ADDENDUM #1:
-ADJUSTED SHEET #
-ADDED ELECTRICAL SHEETS

A1 ADDENDUM #1

NISQUALLY
STATE PARK

PHASE 3A
MAINTENANCE
BUILDING
AND WWTF

GATE LAYOUT -
PUMP HOUSE
A-C8.0

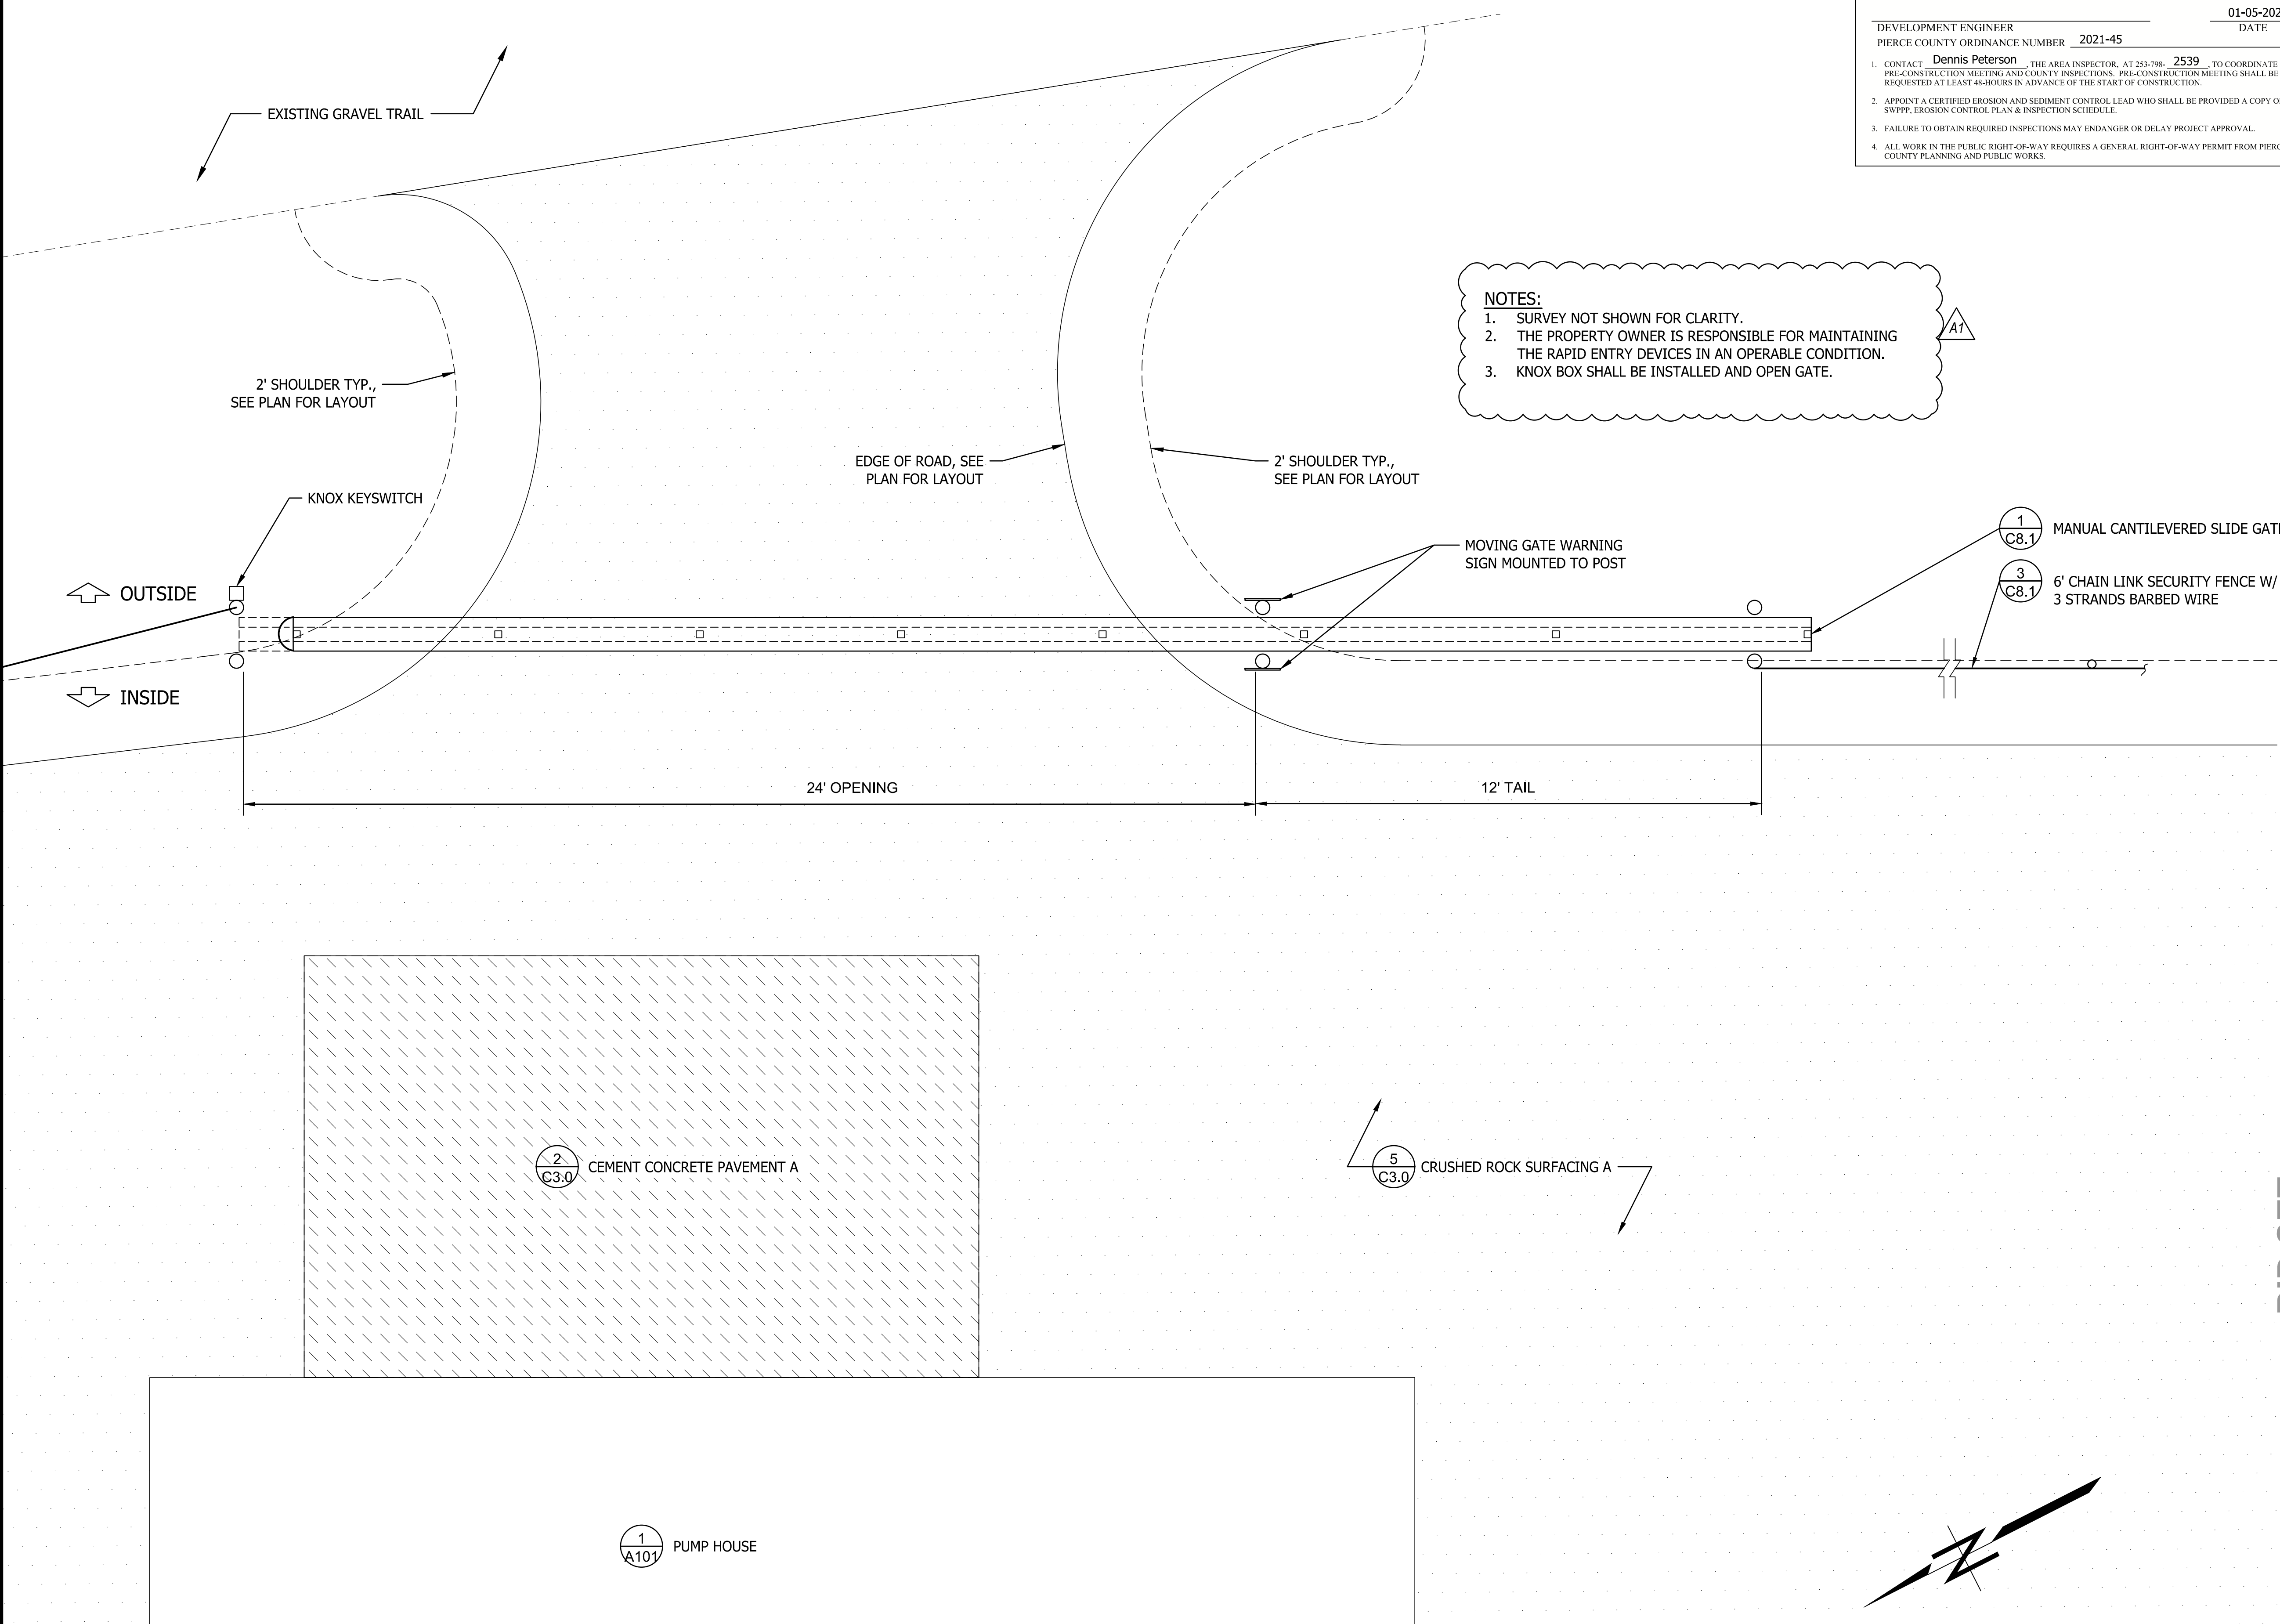
ADDENDUM #1:
-ADJUSTED TO REMOVE ELECTRICAL NOTES FOR MANUAL SLIDE GATE.

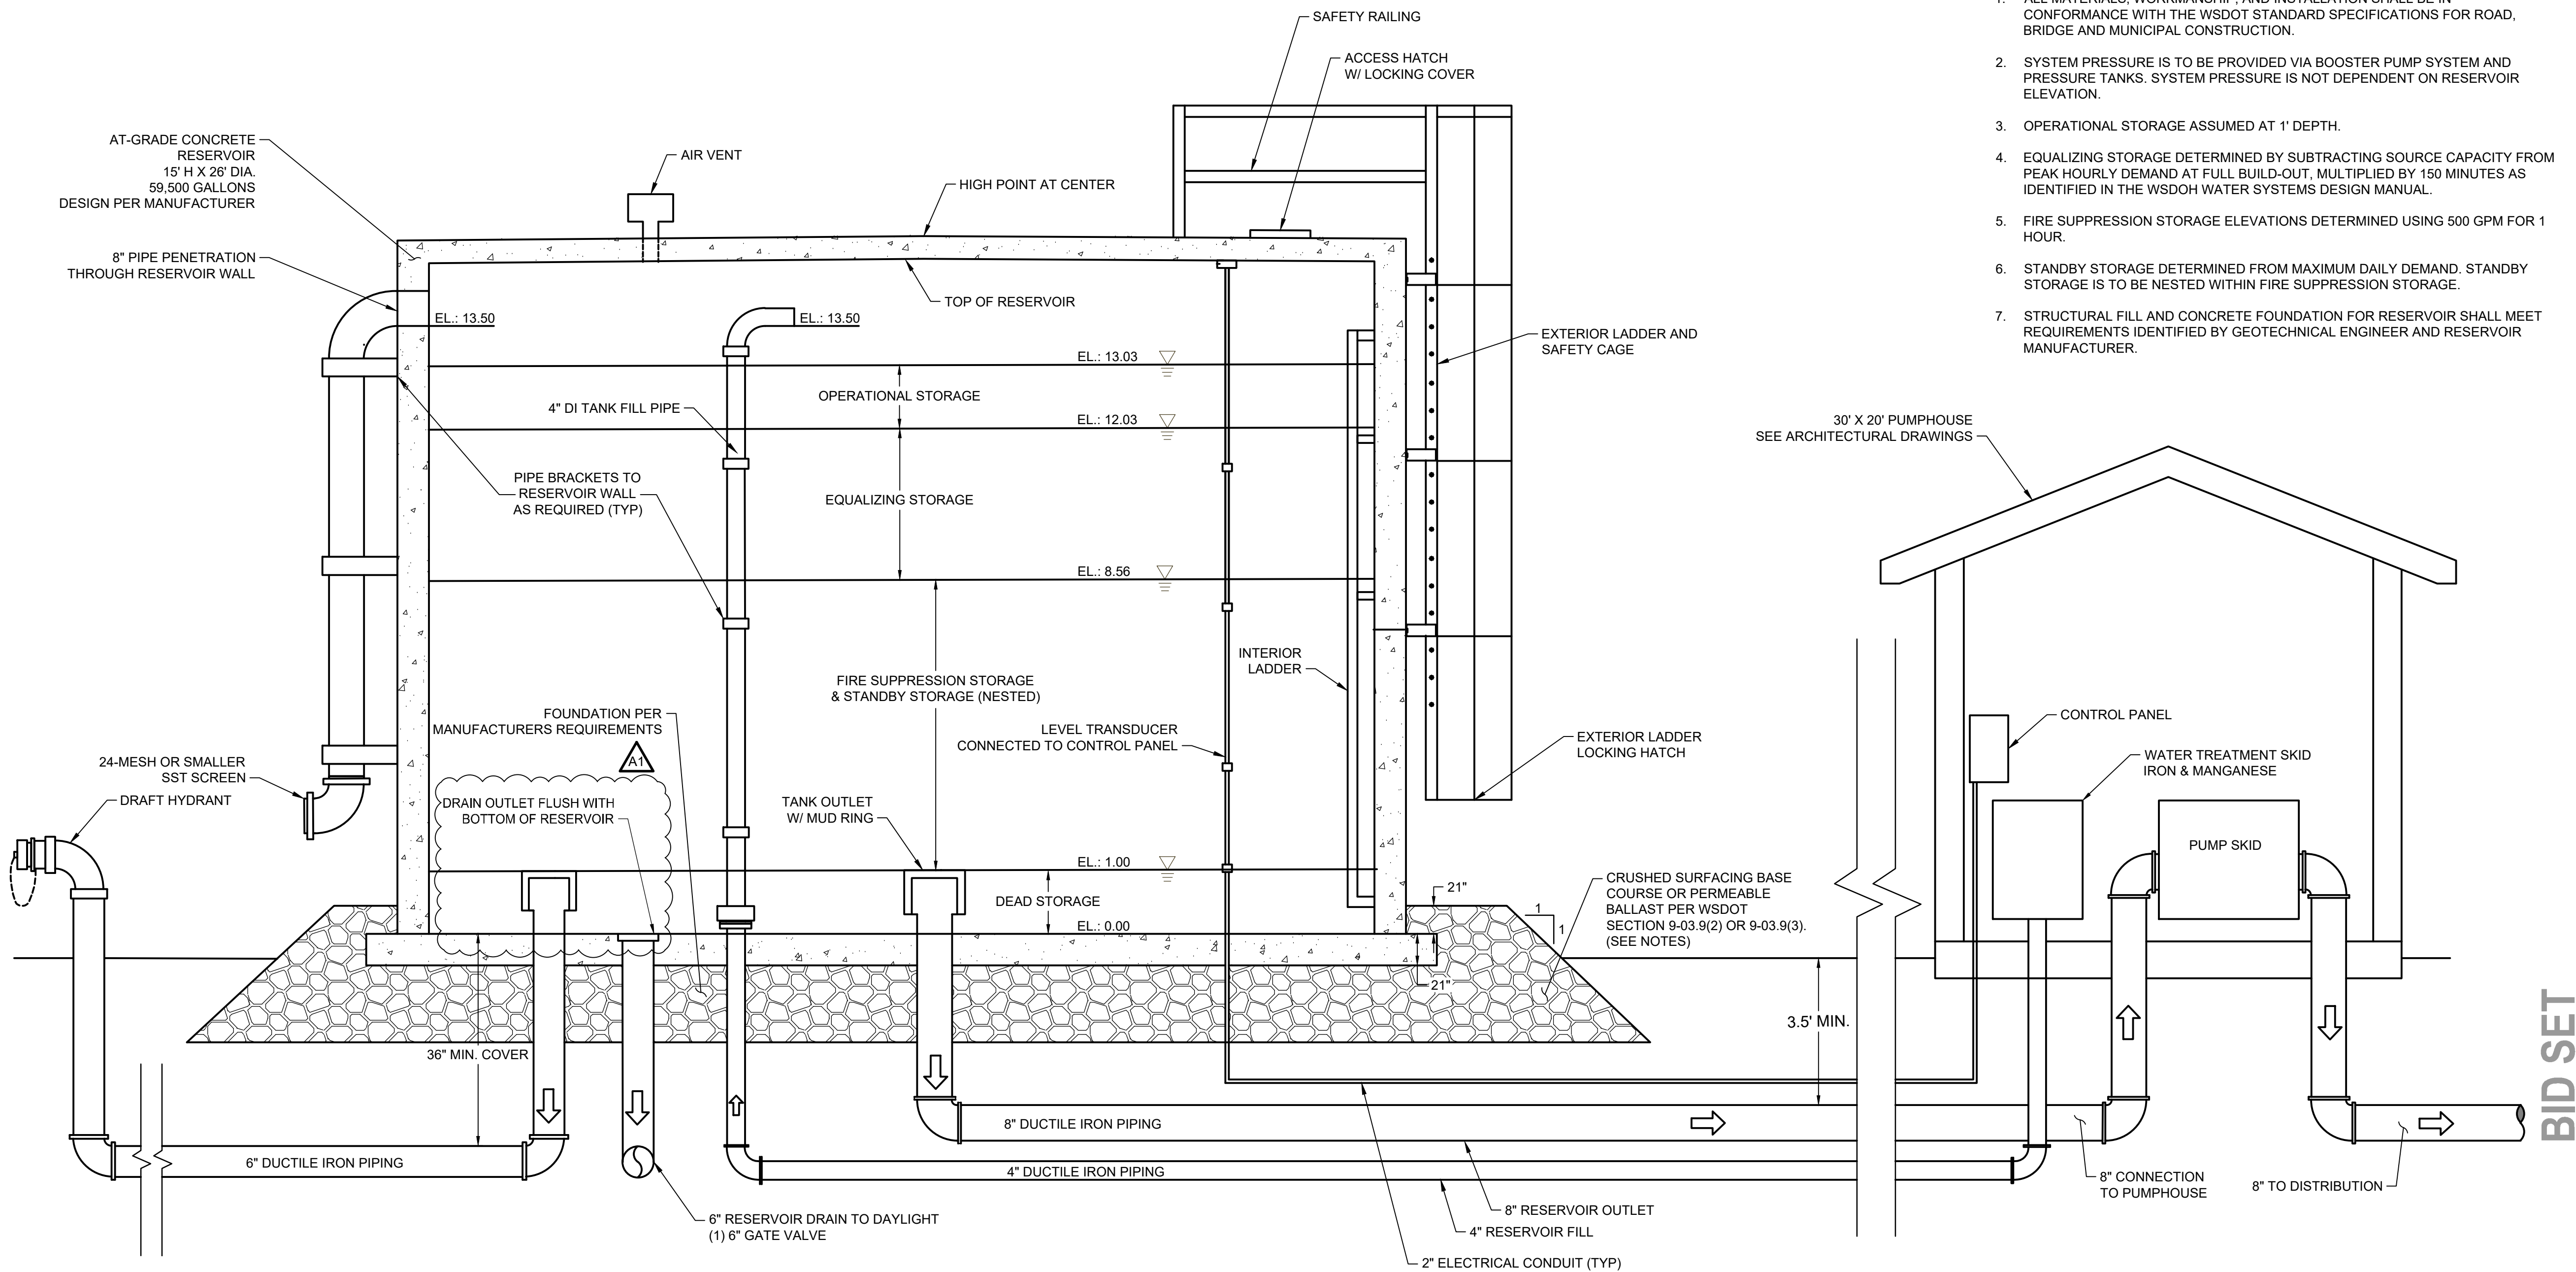
CAD NO.		
6/6/2025		DATE
SDS		APP.
SD		INT.
ADDENDA 1: WATER PLAN AND DETAILS REVISIONS		
NO.		
ACTION		
DESIGNED	SDS	04/03/2025
DRAWN	SD	04/03/2025
CHECKED (FIELD)		
CHECKED (HDQTS.)		
REGISTERED STAMP		
WASHINGTON STATE PARKS AND RECREATION COMMISSION		
NISQUALLY STATE PARK		
PHASE 3A MAINTENANCE BUILDING AND WWTF PUMP HOUSE AREA IMPROVEMENT PLAN C3.12		
SCALE 0 10 20 SCALE IN FEET		
PARKS FILE#
